Access Compliance Report

Public Rights-of-Way (Curb Ramps)

Intersection ID: 29916	Main Street: NORTHRIDGE_DR	Cross Street: WILDBROOK_DR	Location: NE
ADA ID: 26837C758AE7	Ramp Type: PerpDiag	Initial Pass/Fail: Fail	Overall Compliance: No Severity Score: 33.75

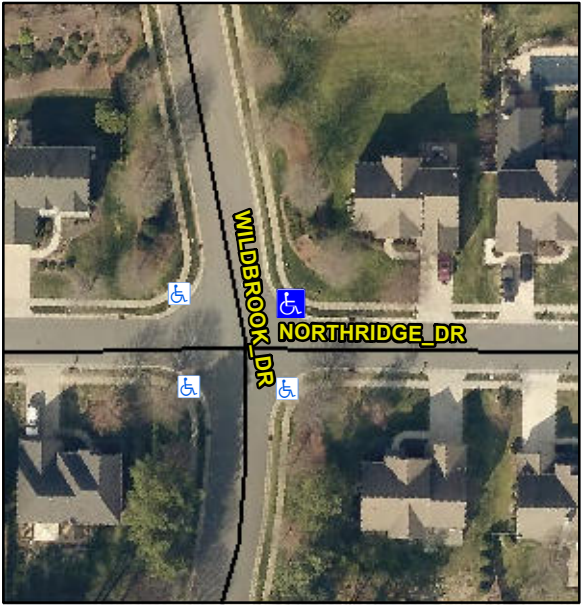
Codes/Mitigation Info/Possible Solution		Field Measurements/Component Compliance					
	Possible Solutions:	Remove & Replace Curb Ramp With Two New Directional Ramps or Equivalent.					
	Surveyor Notes:	N/A					
	PROW/ADA:	R304.5.1, R304.5.3					
	Street 1 Name	WILDBROOK DR					
	Stop Condition-Street 2	None					
	Street 2 Name	NORTHRIDGE DR					
	Stop Condition-Street 1	StopSign					
	Total Cost:	\$ 3200.00					
Compliance	Description	Data	Compliance	Description	Data		
N/A	Ramp Length (in)	51.0	Yes	Ramp Slope (%)	6.9		
No	Ramp Width (in)	44.0	No	Ramp XSlope (%)	7.2		
N/A	Flare Type LT	N/A	N/A	Flare Type RT	N/A		
N/A	Flare Slope LT (%)	N/A	N/A	Flare Slope RT (%)	N/A		
N/A	Flare Traversable LT?	N/A	N/A	Flare Traversable RT?	N/A		
N/A	Landing Length (in)	N/A	N/A	DWS Provided?	N/A		
N/A	Landing Width (in)	N/A	N/A	DWS Contrast?	N/A		
N/A	Landing Slope (%)	N/A	N/A	DWS Length (in)	N/A		
N/A	Landing X Slope (%)	N/A	N/A	DWS Full Width?	N/A
